**TOWN OF ADDISON
BUILDING REPORT**

Facility Information: **Facility Name:** Service Center
Facility Contact: Lisa Pyles **Contact Phone:** 972-450-2878

Accessology Inspector Information:
Inspector: Karen Jackson **Date:** April 17, 2017
Email: Kjackson@accessology.com

Latitude: 32.98127 **Longitude:** -96.839436
Address: 16801 Westgrove Drive **City:** Addison **County:** Dallas

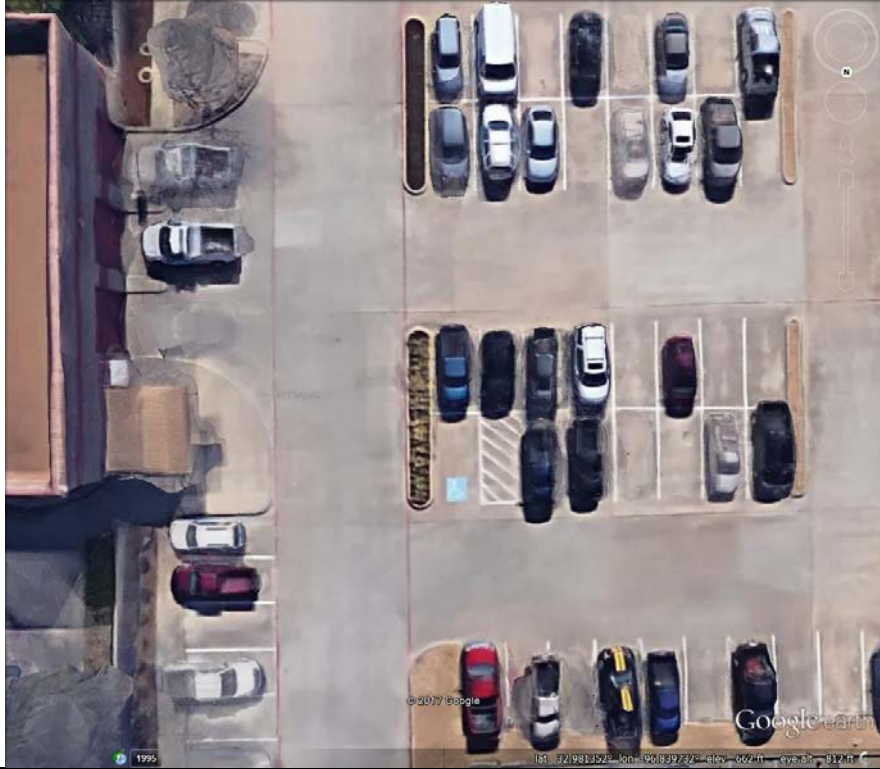
Violation 1 - There are built up curb ramps protruding into the access aisles.

Violation 2 - There are 155 parking spaces provided in the employee lot, only 1 accessible space is provided where 6 are required to be provided.

Rework the curb ramps so they do not project into the access aisles.

Add 5 additional accessible parking spaces with access aisles and compliant signage.

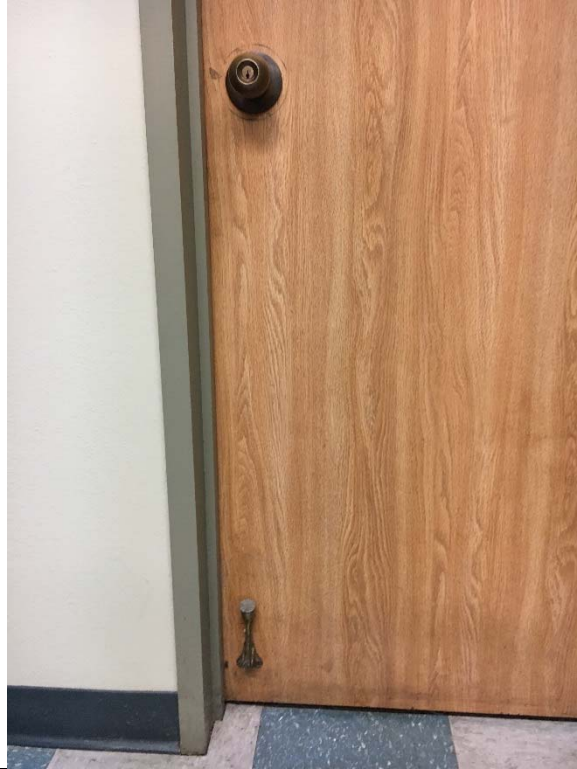
Violation 3 - The accessible parking in the employee lot does not have signage provided.

Violation 4 - There is not a striped cross walk leading from the accessible parking in the employee lot to the sidewalk.

Violation 5 - There are approximately 61 door knobs throughout the facility that require grasping and twisting to operate.

Add a compliant van accessible sign.

Add a marked crossing from the access aisle to the sidewalk.

Possible Solutions: Replace with lever style door hardware.

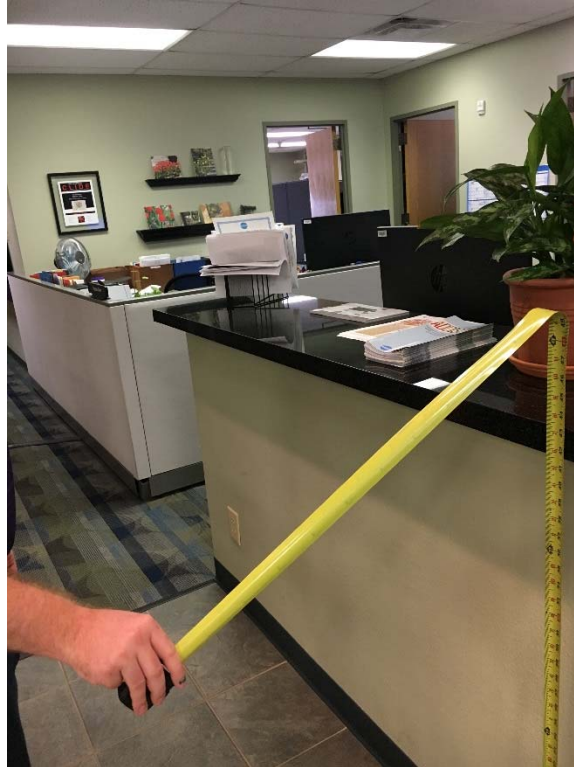
Violation 6 - The copy room in the Special Events area only has a 17" maneuvering clearance on the pull side of the door where a minimum of 18" is required.

Violation 7 - The door in the 1st floor break room and the restrooms serving the break room have fixed door stops and do not have a smooth surface 10" from the bottom of the door.

Violation 9 - The conference room signage has no Braille or tactile characters.

Violation 10 - The back exit door in the conference room only has an 8.5" maneuvering clearance on the pull side where a maximum of 18" is required.

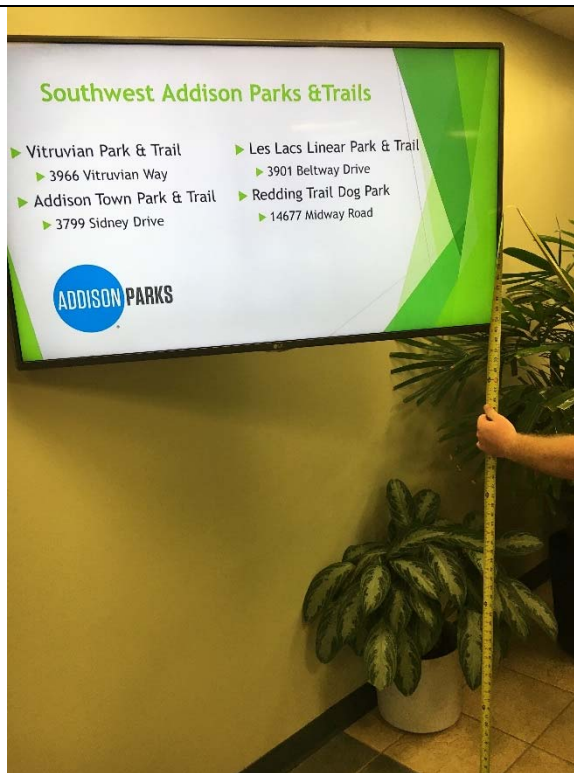
Violation 11 - The Special Events signage does not have Braille provided.

Violation 12 - The counter in the front office is mounted at 43-1/4" above finished floor.

Install compliant signage.

Modify counter to provide a 36" length of counter at 36" high.

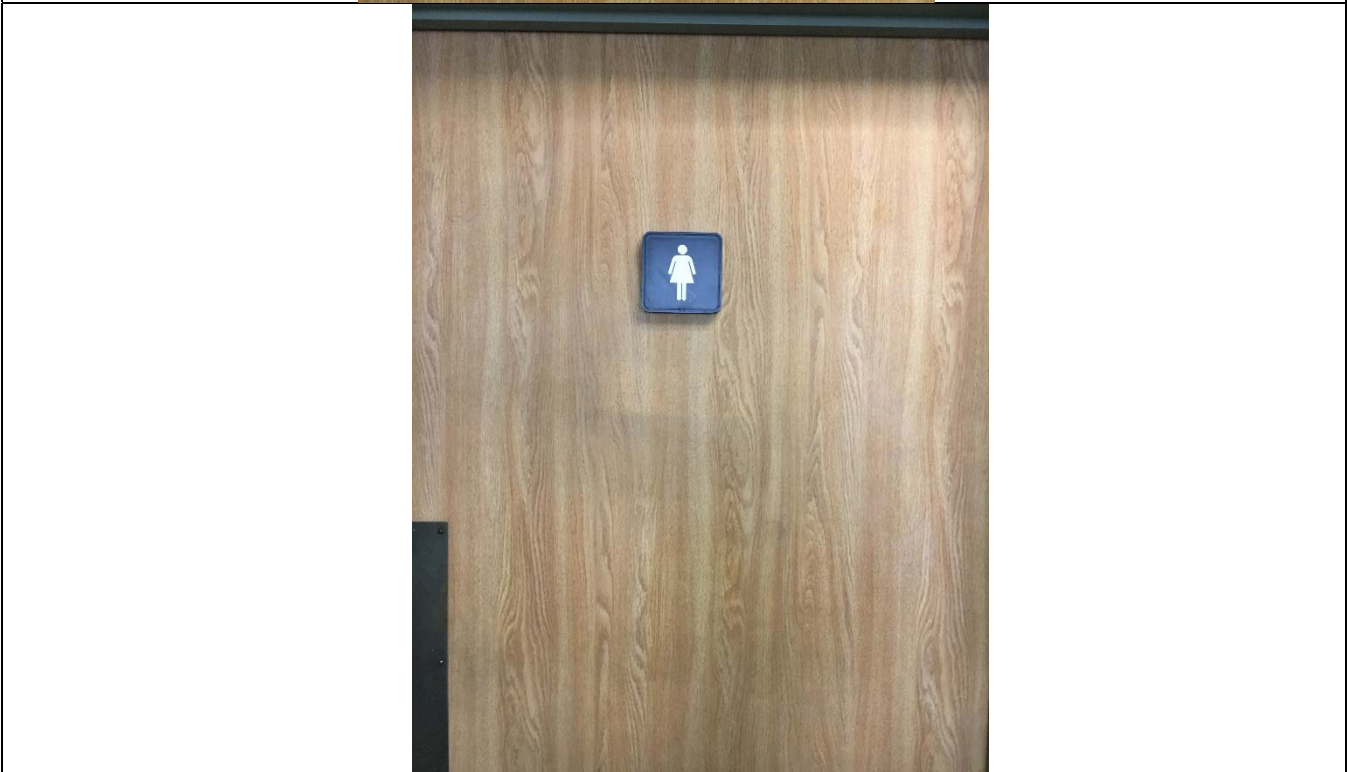
Violation 13 - The TV monitor in the front lobby protrudes into the path of travel.

Relocate TV monitor to a location where it is out of the circulation path or provide a fixed barrier beneath the monitor.

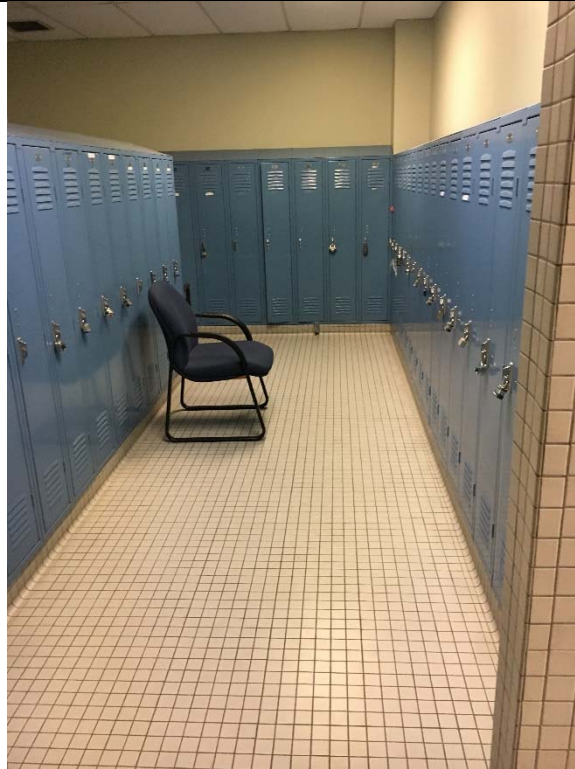
Violation 20 - Breakroom Area: Men's room has 3 urinals and no accessible urinal is provided.

Violation 21 - Breakroom Area: Men's restroom does not have an accessible toilet compartment.

Lower one of the urinals to provide 17" maximum high rim.

Make modifications to restroom to provide fully accessible toilet compartment.

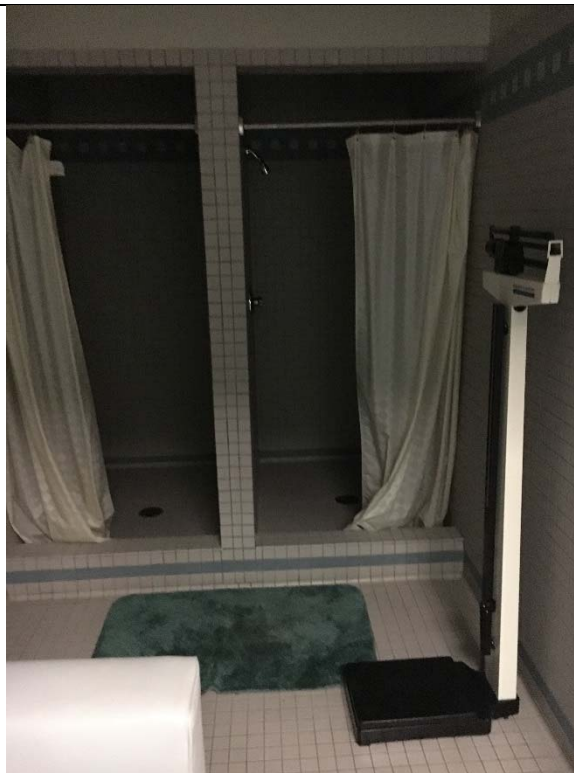
Violation 22 - Breakroom Area: Men's restroom does not have an accessible shower compartment.

Violation 23 - Breakroom Area: Men's room locker area has no accessible bench.

Violation 24 - Breakroom Area: Women's restroom lavatory faucets require grasping and twisting to operate and it does not have the required knee clearance.

Modify shower room to provide a fully accessible shower compartment.

Provide a compliant bench.

Replace with lever style hardware and remove the cabinet below to allow for the required knee clearance.

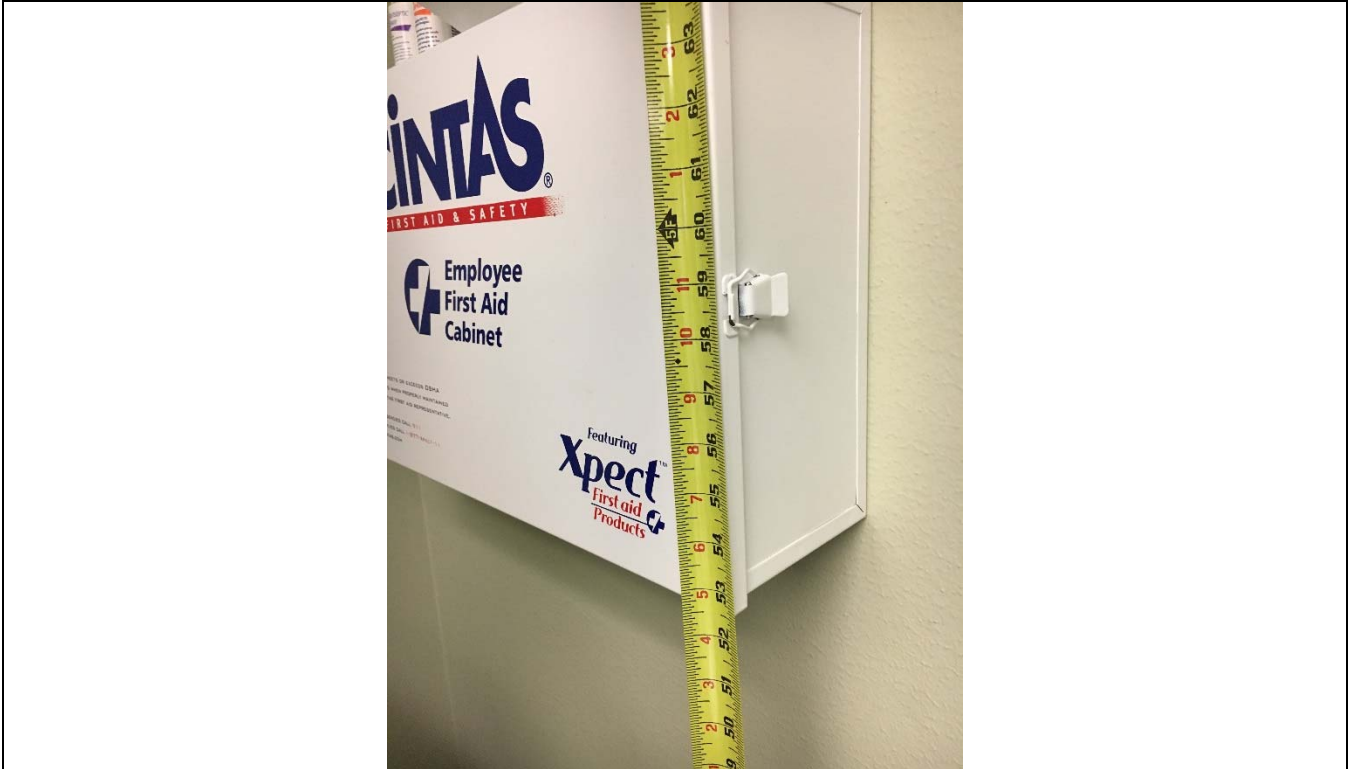
Violation 44 - The counter/sink in the 1st floor break room is at 36 5/16" above finished floor.

Violation 45 - The counter/sink in the 2nd floor break room is at 36" above finished floor.

Possible Solutions: Modify sink and counter to provide 34" maximum height.

Modify sink and counter to provide 34" maximum height.

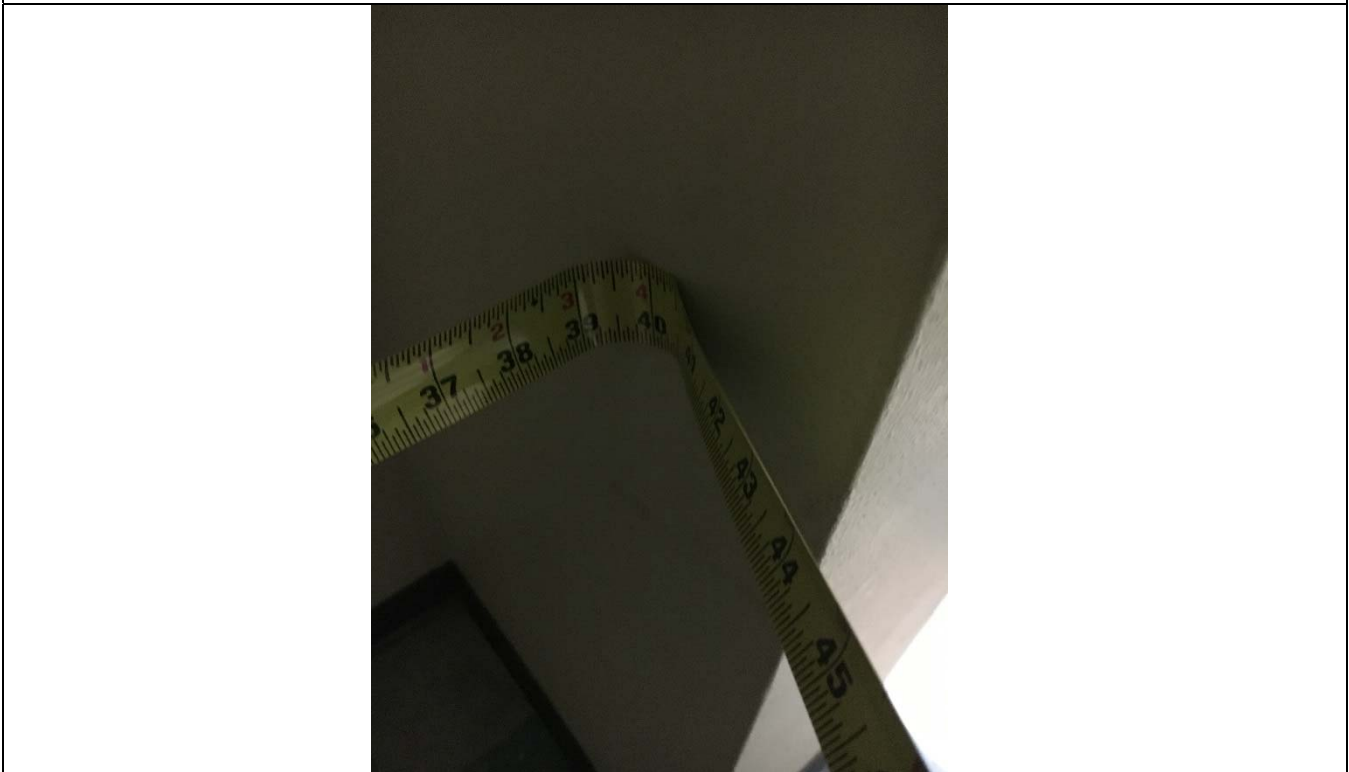
Violation 46 - The phone provided in the break room on the 2nd floor is mounted at 56" to the highest operable part.

Violation 47 - The first aid box mounted on the wall in the 2nd floor break room is mounted with the operable part at 58.5" above finished floor.

Lower phone so the highest operable part is no higher than 48" above finished floor.
